NEW RESIDENCE

1385 HILLSIDE CIRCLE, (LOT 1) BURLINGAME, CA
A.P.N.: 000-000-000

Kiely Arborist Services LLC
 Certified Arborist WE#10724A TRAQ Qualified
 P.O. Box 6187
 San Mateo, CA 94403
 650-532-4418

A.1.1

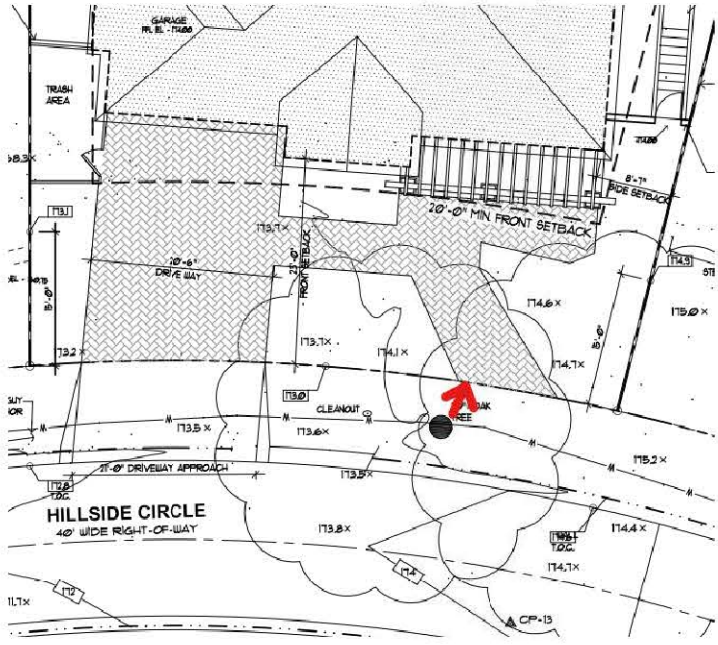
Impacts/Recommendations:
Oak tree #1 is to be retained. The tree is adjacent to an existing driveway. It is recommended to temporarily retain the existing driveway near this tree when underneath the dripline of the tree during the building phase of the project. Temporarily retaining the driveway will act as a tree protection measure and will help to increase staging and access to the site, as removing the driveway at the beginning of the project would make for a larger tree protection zone needed with the fencing being located at the tree's drip line. The existing grade within the tree's dripline is recommended to be retained as is where possible. No grading or excavation is recommended to take place within 10' from this tree (6x diameter) except for the removal of the driveway. At the end of the project, when it is time to demolish the existing driveway near this tree, the Project Arborist is

recommended to be on-site to document and witness the removal of the driveway. A jackhammer is recommended to be used when working within the tree's drip line to break the concrete material into hand manageable-sized pieces. Once broken down the driveway material is recommended to be removed by hand. Exposed roots during the process are recommended to be wrapped in layers of wetted-down burlap to avoid root desiccation. The existing driveway area is recommended to be filled back in once the driveway has been removed so that no roots are exposed to the elements. When backfilling the soil in this area, the area is also to be irrigated. The proposed driveway is further from the tree than the existing driveway and outside of the 10' range and is not expected to have impacts on the tree. The tree is recommended to be deep water fertilized with Nutriroot once the work near the tree has taken place as a mitigation measure for any minor impacts that may take place.

Plan change needed:
A new pathway is proposed at 4' from oak tree #10. This is too close to the tree and impacts would be expected. It is recommended to maintain a minimal clearance of 10' from the tree to the pathway to keep impacts on the tree low. With this plan change implemented, impacts are expected to be minor and will be mitigated by the recommended deep water fertilizing with Nutriroot.

A new pathway is shown adjacent to valley oak tree #2. It is recommended to have the pathway no closer to the tree than the existing pathway next to the tree. This may result in a plan change. All landscaping work below the dripline of the tree is recommended to be done by hand under the direct supervision of the project arborist. Excavation is recommended not to exceed 6" for any landscaping when underneath the tree's dripline. No roots measuring larger than 1.5" in diameter shall be cut for landscaping purposes. No grading shall also take place underneath the tree's dripline.

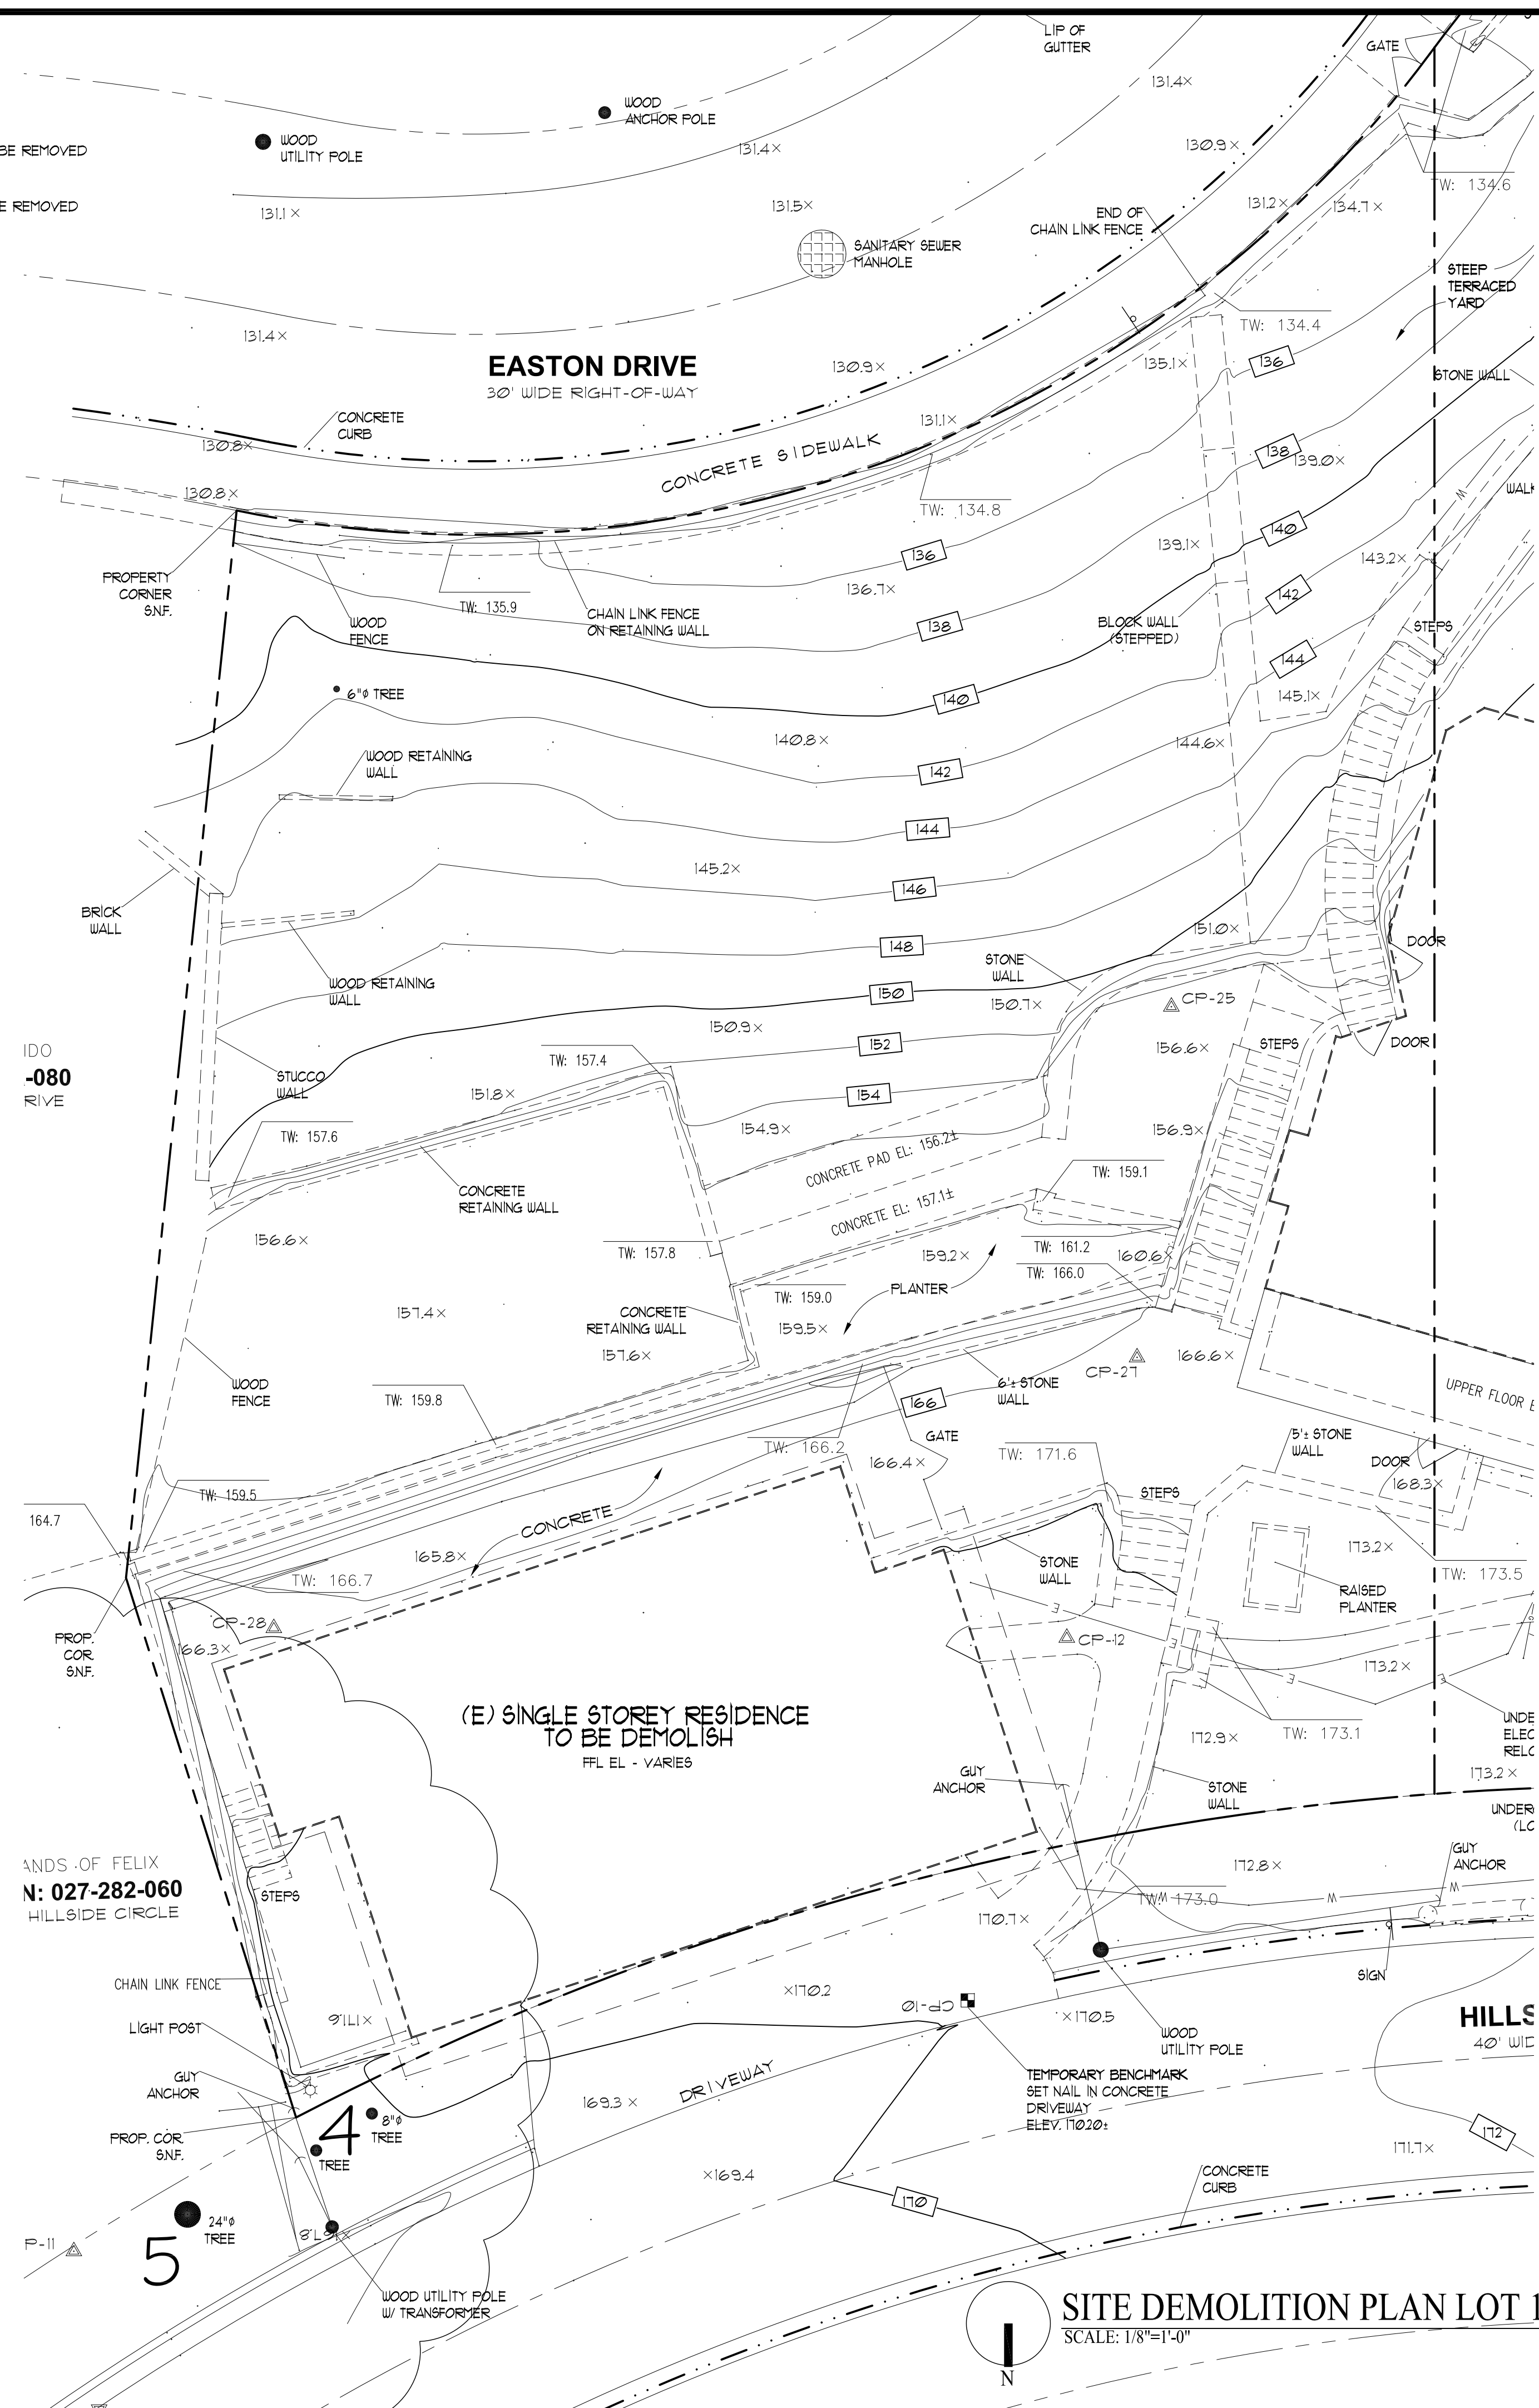
ENSURE THAT TREE PROTECTION SPECIFICATIONS ARE SHOWN GRAPHICALLY ON SITE PLANS FOR CONTRACTOR TO FOLLOW, AS FOLLOWS:

LOCATION OF ALL TREE PROTECTION MEASURES INCLUDING BUT NOT LIMITED TO FENCING, TRUNK WRAP, ROOT BUFFER, ARE TO BE GRAPHICALLY SHOWN ON DEMO PLAN A2 SO THAT CONTRACTOR CAN EASILY INSTALL AND EXECUTE THE TREE PROTECTION MEASURES.

LOCATIONS OF HAND DIGGING AND LOCATIONS OF WORK TO BE UNDER PROJECT ARBORIST SUPERVISION ARE TO BE GRAPHICALLY SHOWN ON THE RELEVANT SITE PLAN SO THAT CONTRACTOR(S) CAN EASILY UNDERSTAND AND EXECUTE THE SPECIFICATIONS. WORK WITH THE PROJECT ARBORIST TO PRODUCE ACCURATE INFORMATION ON THE RELEVANT SITE PLAN. SOME OF THE INFORMATION WILL BE ON THE A SHEETS AND SOME ON THE L SHEETS.

ARBORIST REPORT RECOMMENDS:
RETAINING SOME OF THE DRIVEWAY NEAR TREE 1 AND BREAKING IT DOWN BY HAND LATER IN THE PROJECT. PUT THIS ON DEMO PLAN A2 SO CONTRACTOR CAN FOLLOW IT.
CHANGING THE PATHWAY NEAR TREE 10 TO AVOID ROOT LOSS/DAMAGE. WHERE IS TREE 10? HAS THE PATHWAY BEEN CHANGED?

ARBORIST REPORT IS BASED ON REVIEWING L PLANS DATED JAN 2024, LOT 1 A PLANS DATED 10-26-22, LOT 2 A PLANS DATED 10-26-21 AND LOT 3 A PLANS DATED 10-26-21. NO CIVIL PLANS REVIEWED. NOTE THAT THE CONTENT OF CIVIL PLANS MAY NECESSITATE A CHANGE IN THE ARBORIST RECOMMENDATIONS.

PROVIDE THE BOTANICAL NAME (GENUS AND SPECIES) AND LOCATION OF THE REQUIRED LANDSCAPE TREES, AND WHETHER THEY ARE EXISTING OR NEW FOR EACH LOT.
